# 6th ACSF meeting

## Tokyo, 19-21 April 2016

Industry proposals for  
ACSF status definition and HMI

### Comments 2:

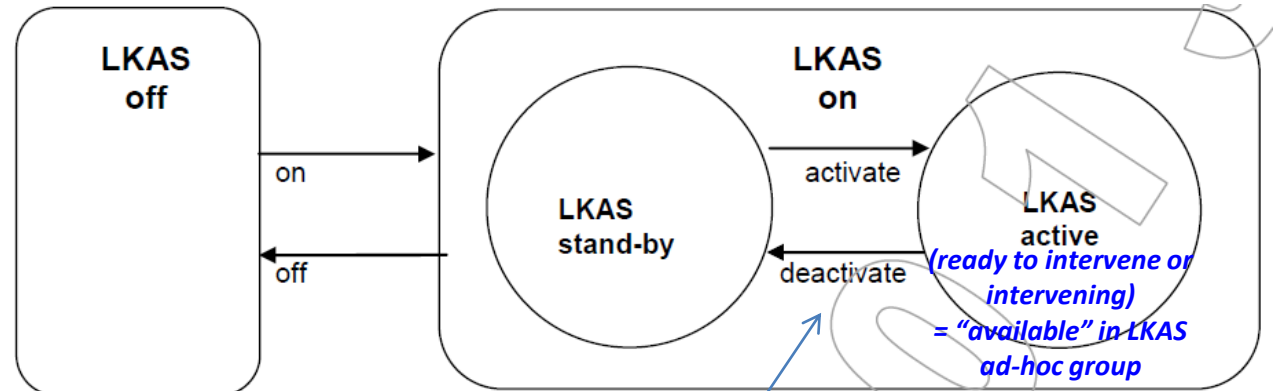
- “especially” is unspecific
- Specific requirements to category should be in 5.6.1.1.7
- Proposal to delete text in [ ]

# What does “operational” mean?

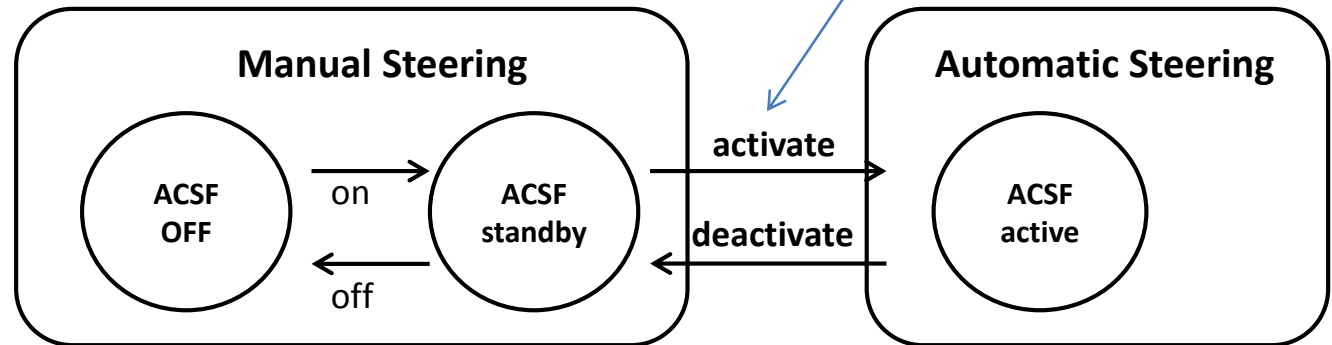
Remark →

Automatic activation when the conditions for operation are fulfilled

No automatic activation when the conditions for operation are fulfilled, deliberate action from driver required.

**What does “operational” mean:**

- A. “switched on”
- B. “active”**
- C. “the system is able to intervene without further action or confirmation by driver“ ...?
